## ADDENDUM

NO. 3

**PROJECT NAME:** Johnson High School 2025 Additions and Renovations

**ADDENDUM DATE:** 15 May, 2025

## 1 FOUNDATION PLAN - AREA A

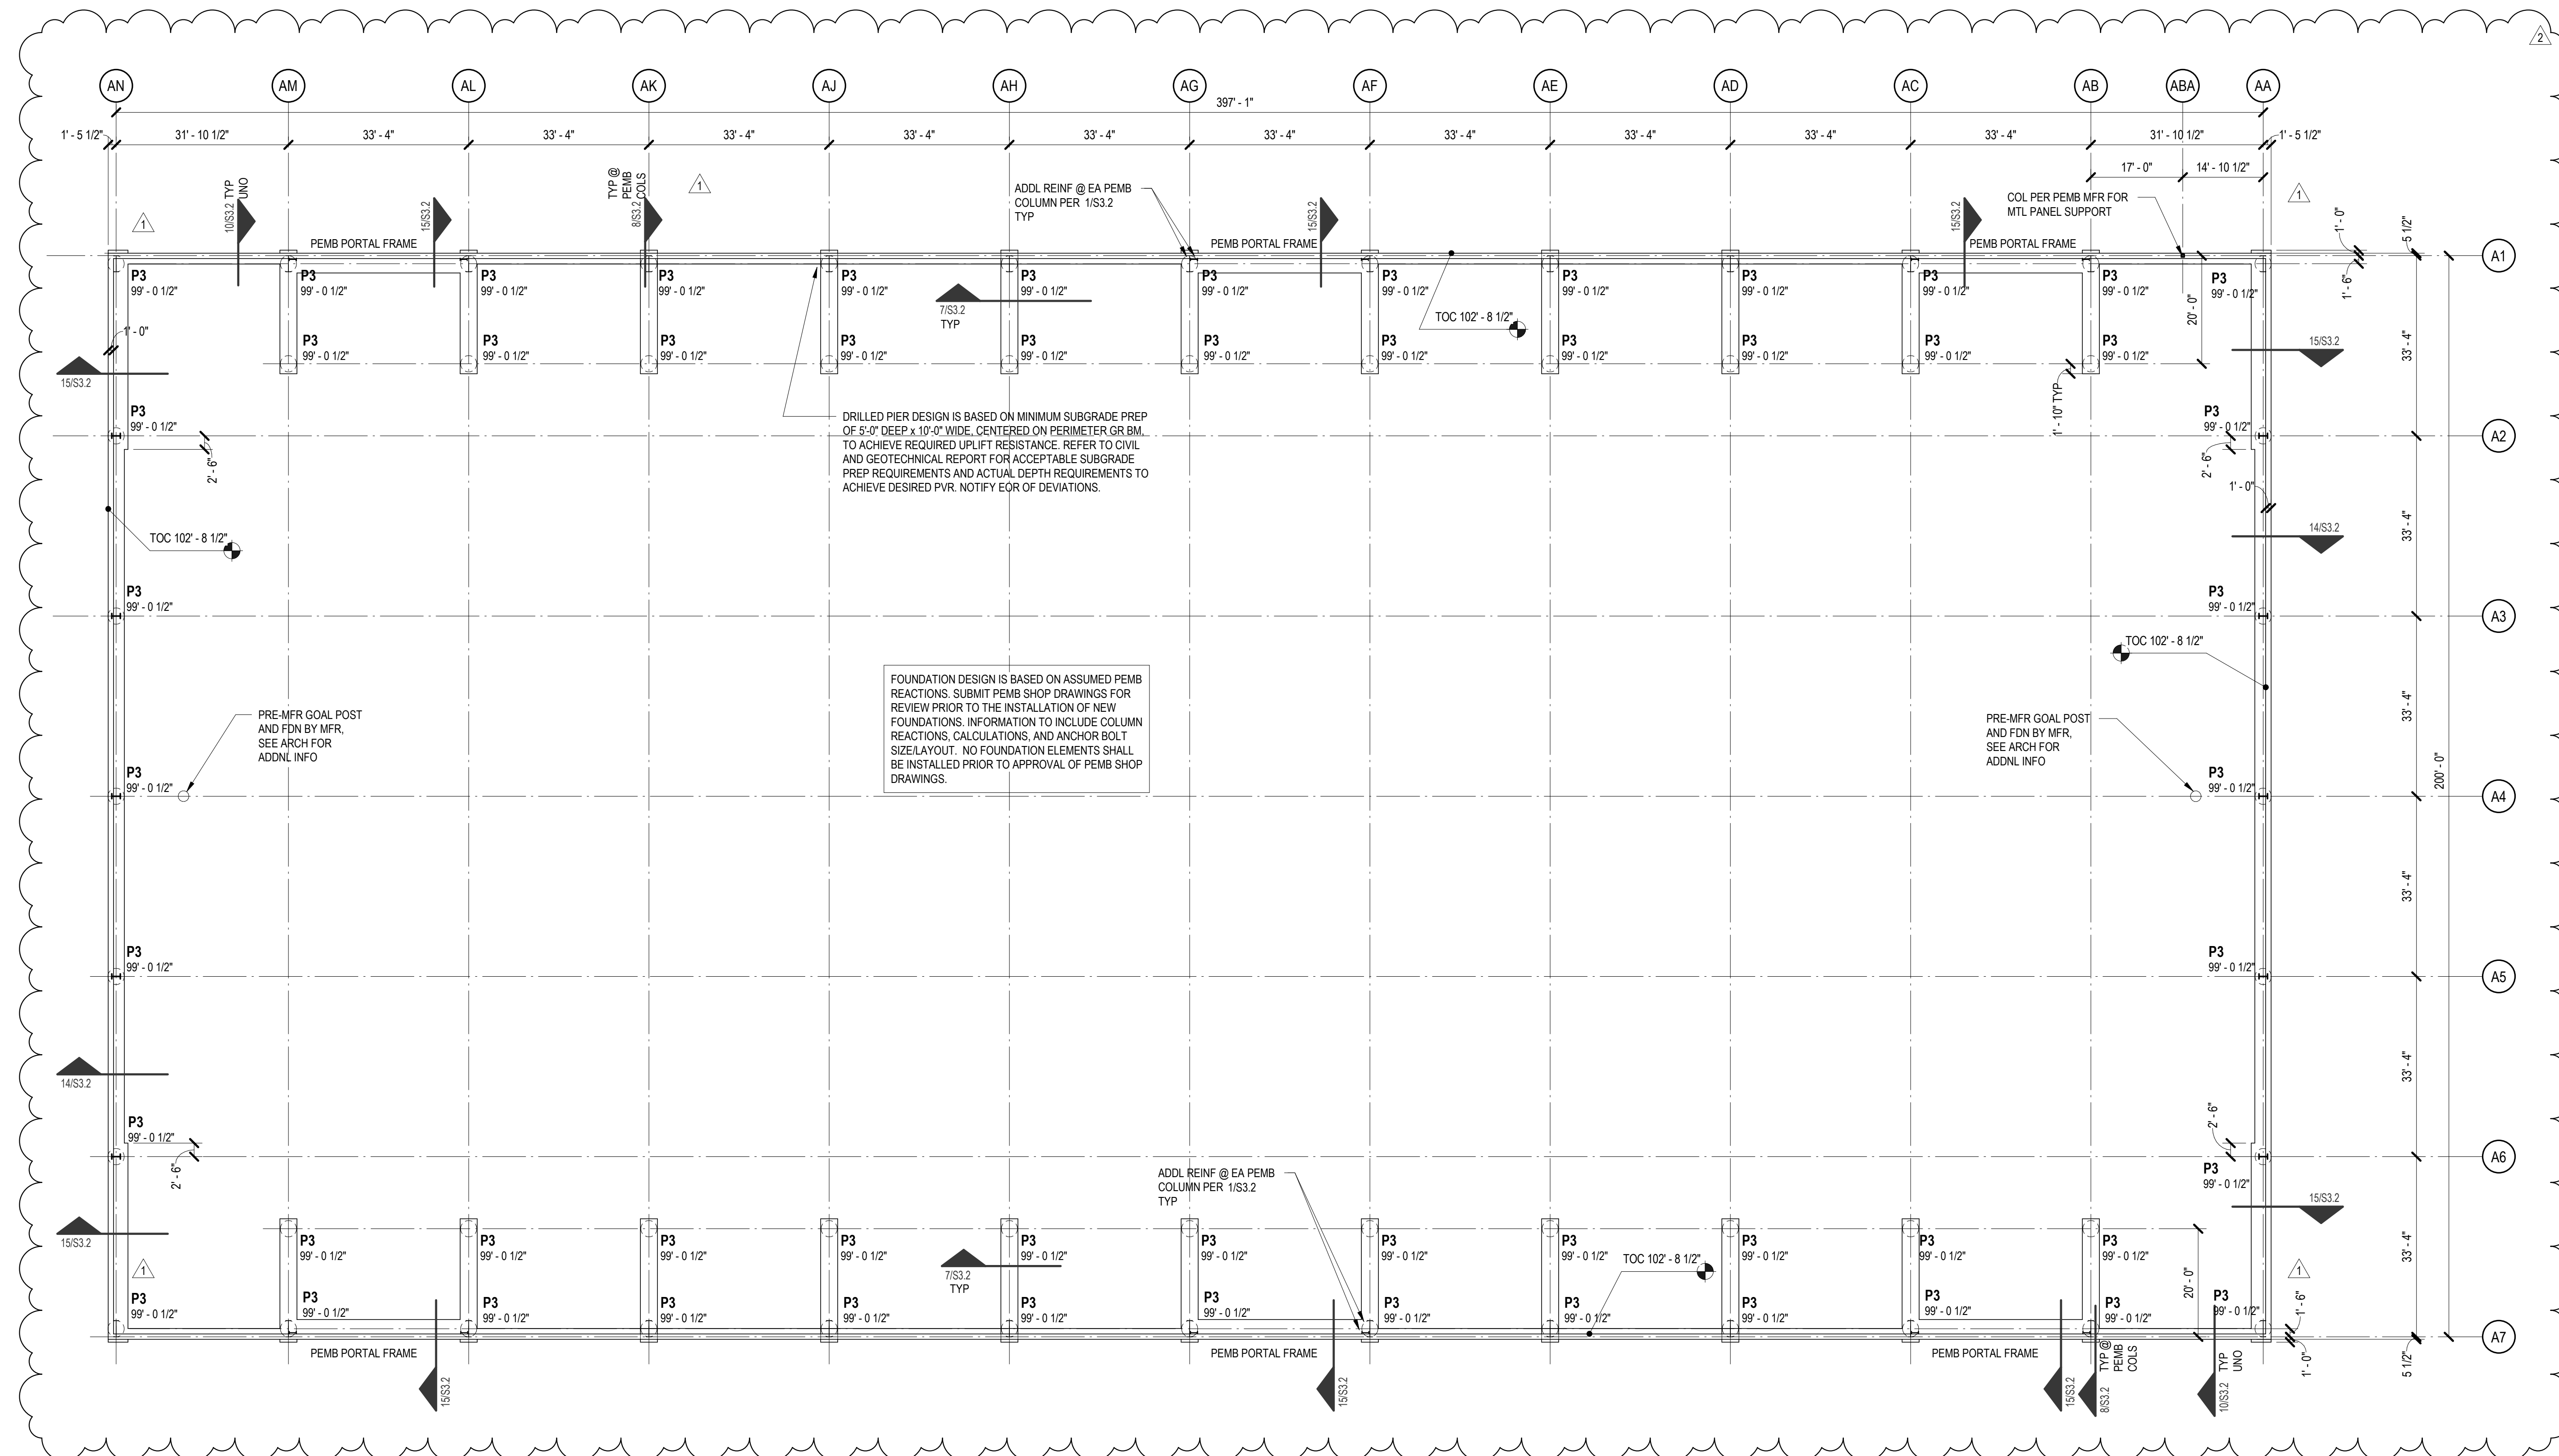
**AD No 3, Struct Item 2: To the Drawings, Sheet S2.1A1 "FOUNDATION PLAN – AREA A",**

- 1) Revised overall dimensions for building.

# 1 ROOF FRAMING PLAN - AREA A

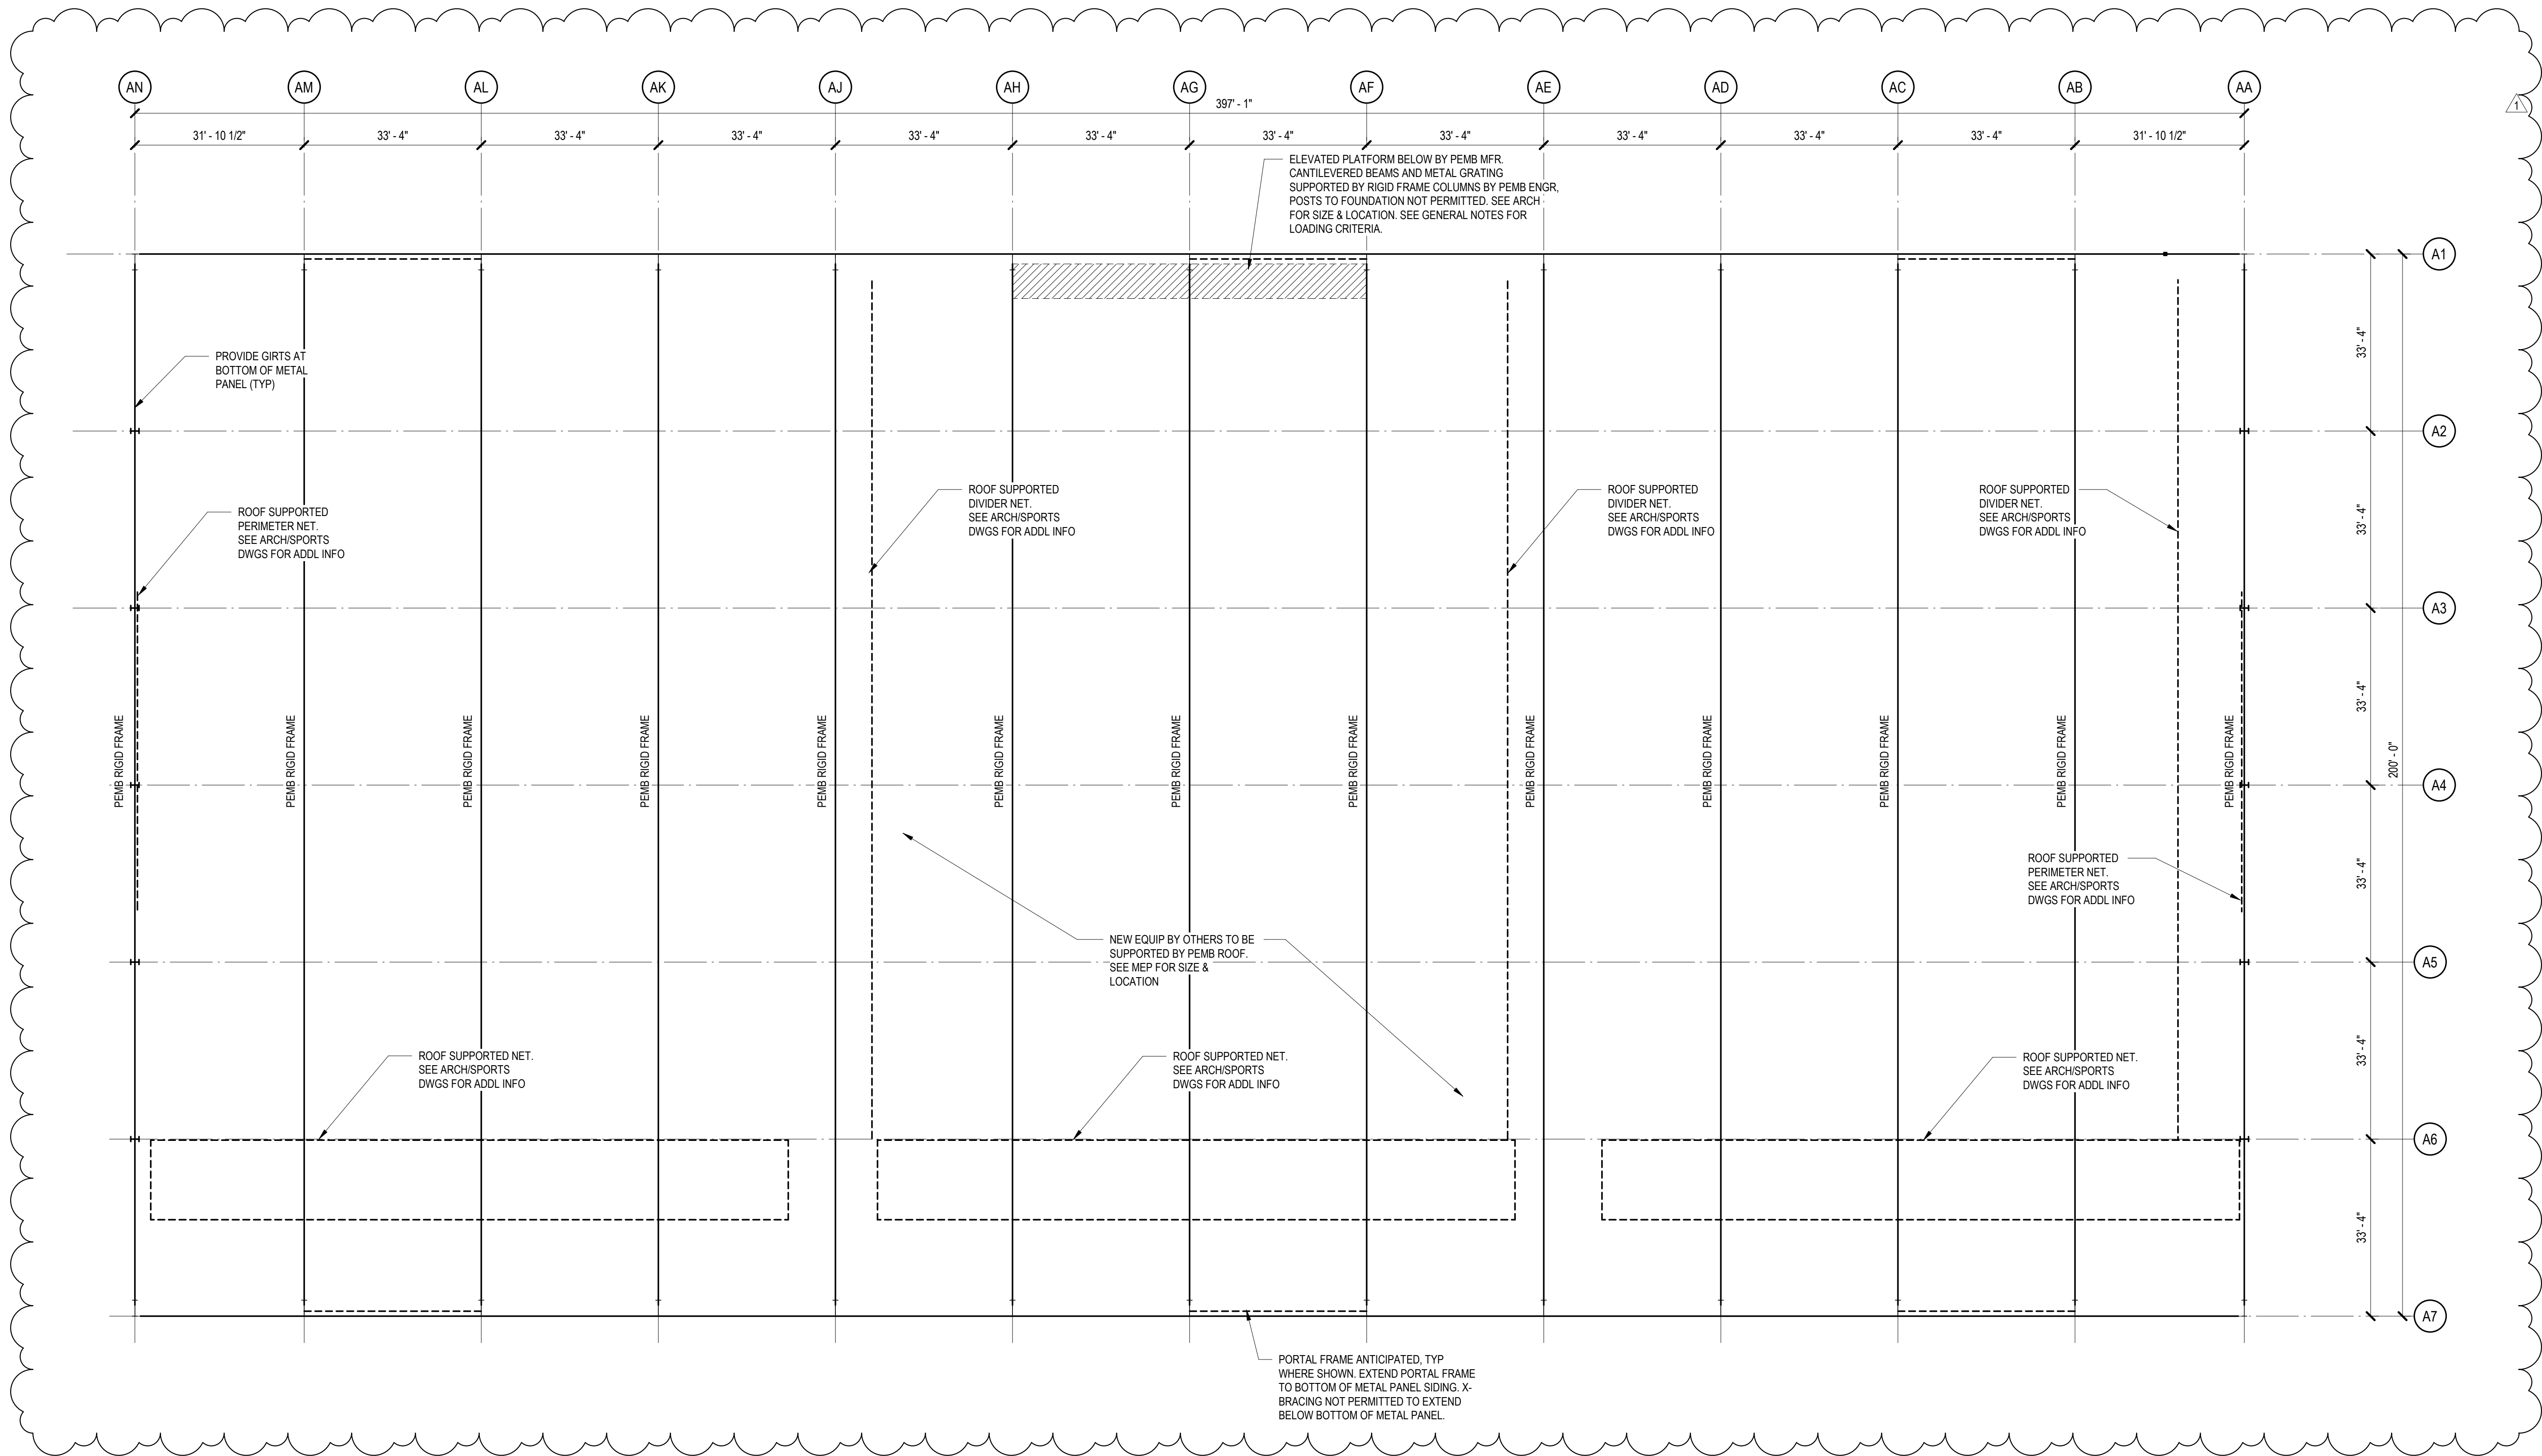
**AD No 3, Struct Item 3: To the Drawings, Sheet S2.1A2 "ROOF FRAMING PLAN – AREA A"**

- 1) Revised overall dimensions for building.

## 1 FOUNDATION PLAN - AREA B

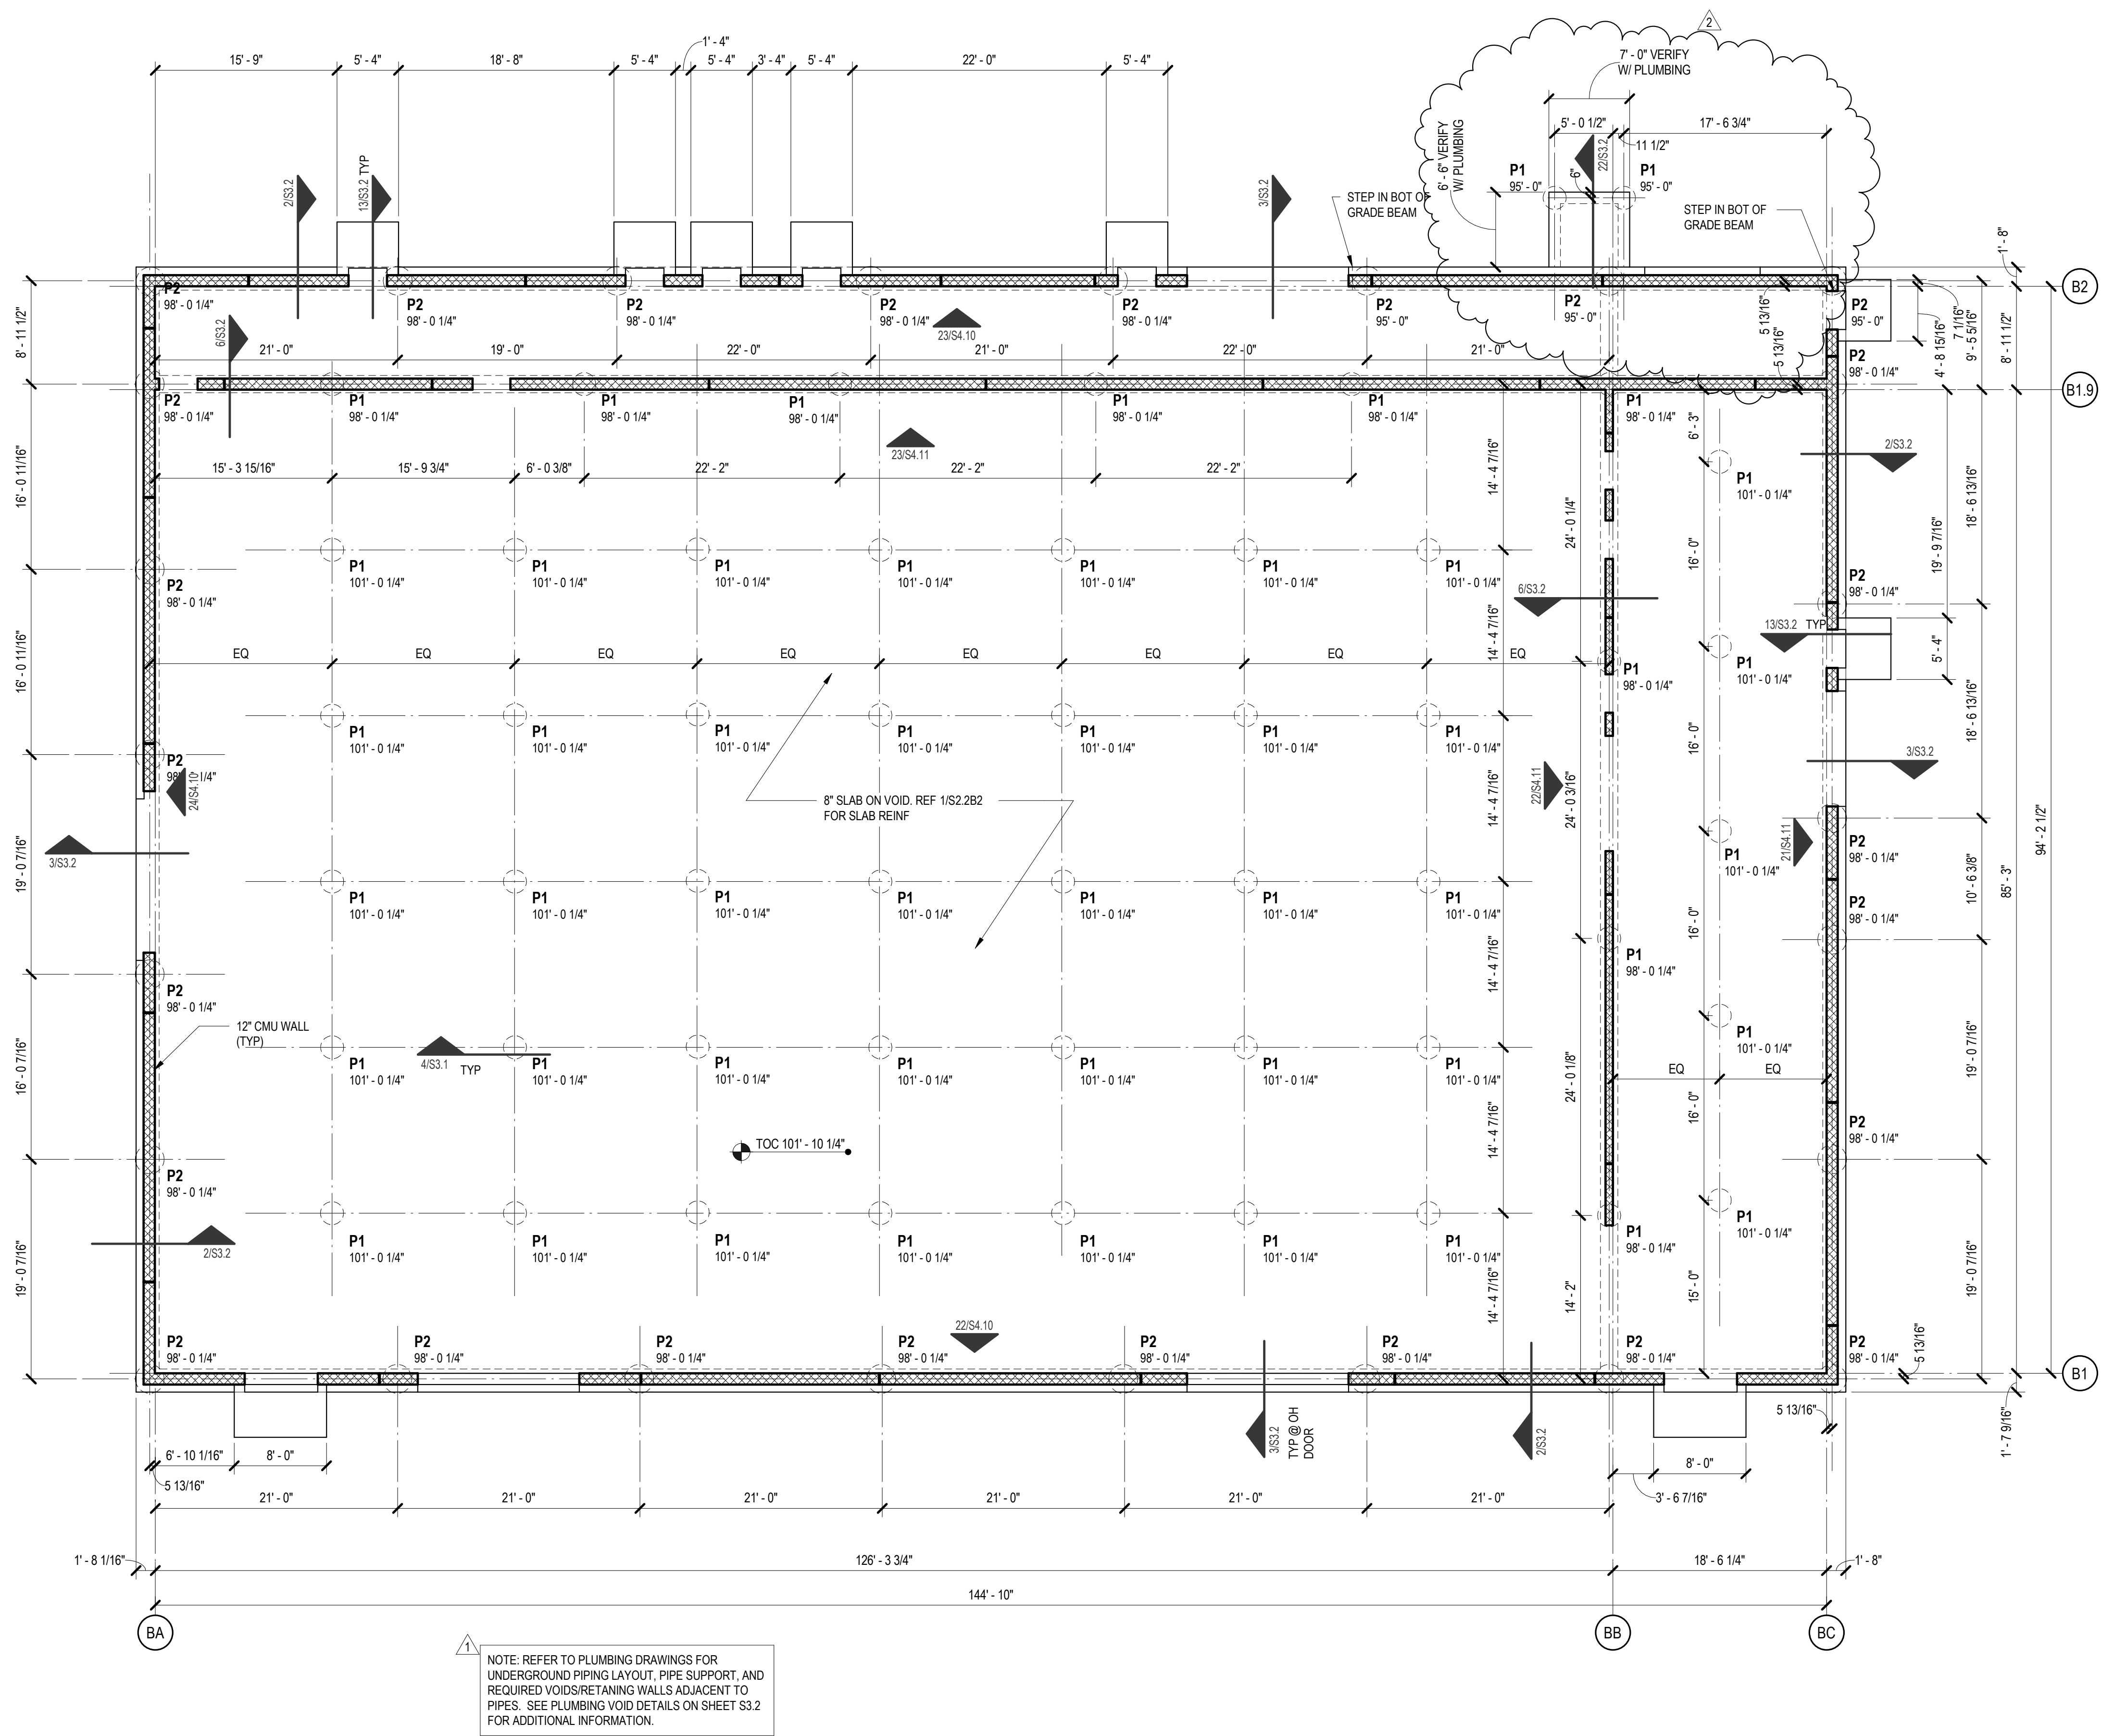
**AD No 3, Struct Item 4: To the Drawings, Sheet S2.1B1 "FOUNDATION PLAN – AREA B"**

- 1) Revised location of plumbing vault.
